JUN 17 2011

**Re: Minor Modification to Resource Recovery and Protection Plan, Longwall Panel # 23, West Ridge Mine, Utah American Energy, Inc.**

**WEST RIDGE MINE**  
**Map 5-4A**  
**Mining Projections**

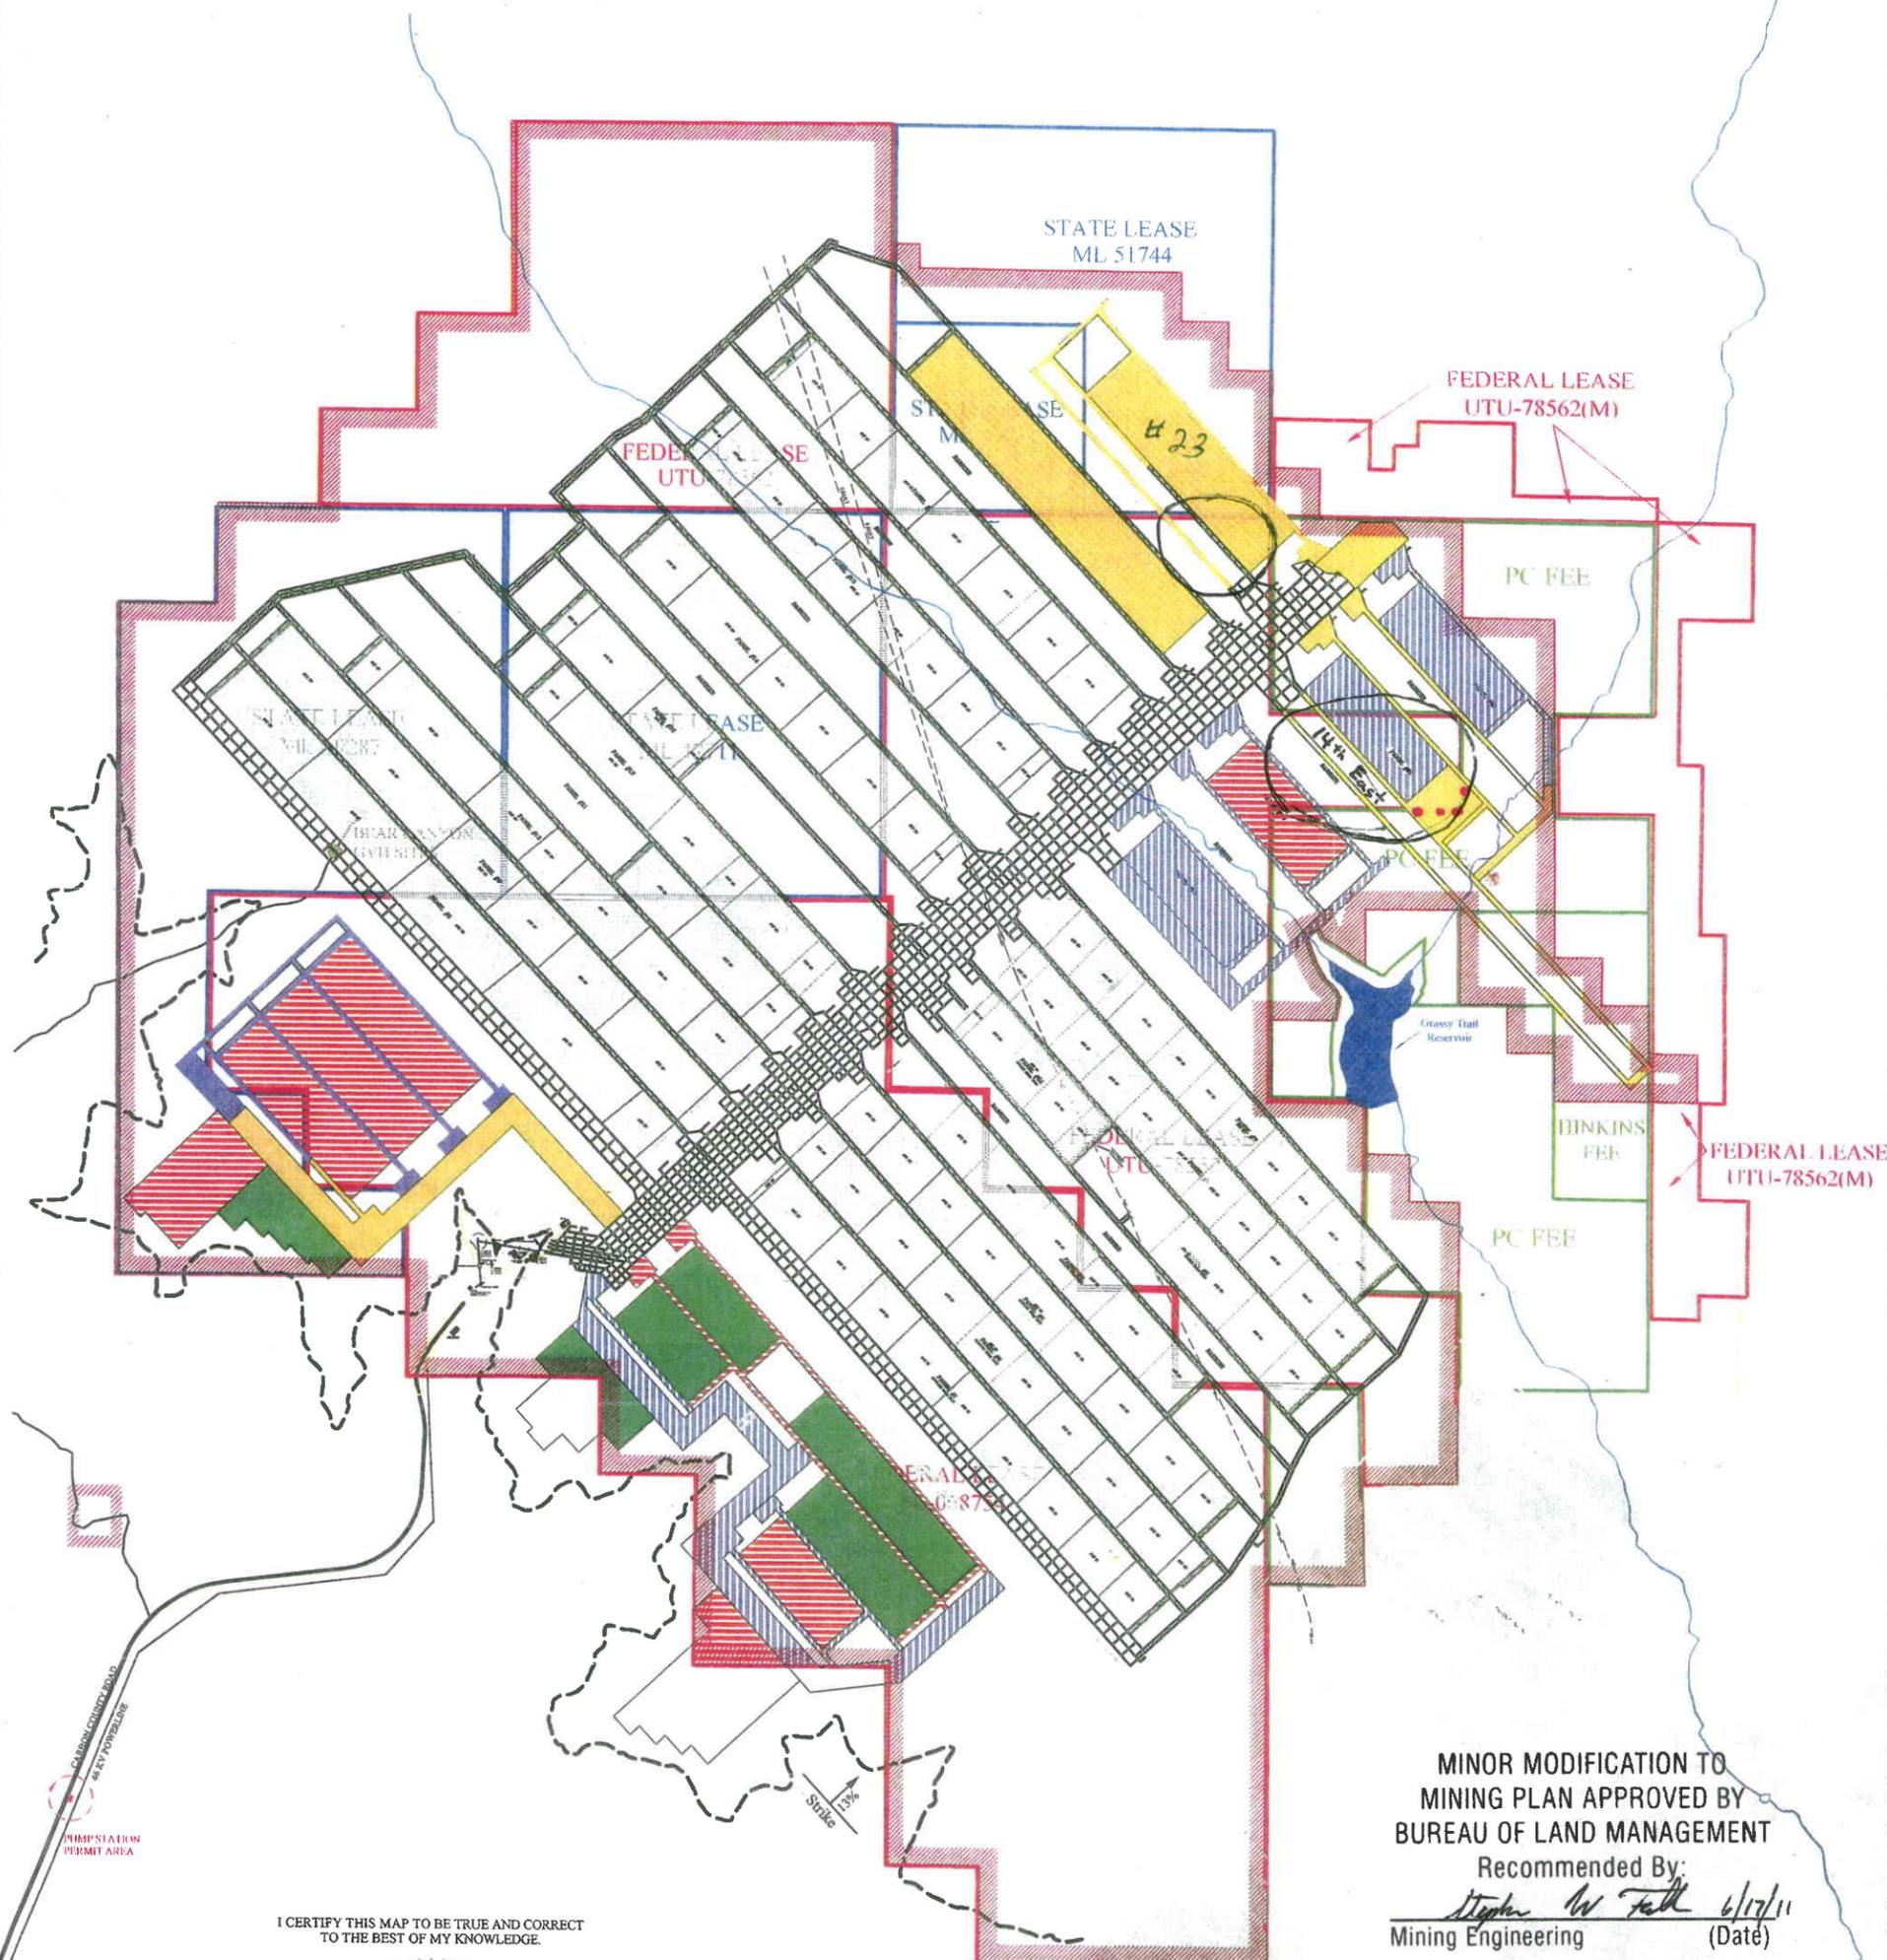
**Approval:** The R2P2 modification is approved as submitted for longwall panel # 23 for only the portions of the mining area on Federal coal lease UTU-78562. As you are aware, approval for the coal lands not on Federal coal (State coal leases ML-47711 and ML-51744) will require approval from State of Utah School and Institutional Trust Lands Administration. Authorization to mine this panel is subject to all conditions and approvals from MSHA. In addition, the longwall development entry configuration (two sets of two entry tailgate and bleeders entries, 14<sup>th</sup> East) on the right side of the Main Entries is also approved as shown on the enclosed approval map. Only a short beginning length of the 14<sup>th</sup> East development entries is on the Federal coal lease. The lengths of the longwall panels on this right side may change from ongoing proposed changes but all are on non-federal coal and will not affect this approval.

As part of this approval, the certified mine map needs to be consistent in naming the appropriate longwall panels with other agency submissions such as with MSHA and Utah Division of Oil Gas and Mining. One longwall naming or numbering convention needs to be established for all agencies involved. Please update the certified mine map with the established longwall numbering convention and provide evidence to this office within 30 days.

The BLM has determined that this modification complies with the Mineral Leasing Act of 1920, as amended, the regulations at 43 CFR 3480, and the lease terms and conditions. The modification is approved as depicted on the enclosed mine map with regards only to the Federal coal on lease UTU-78562.
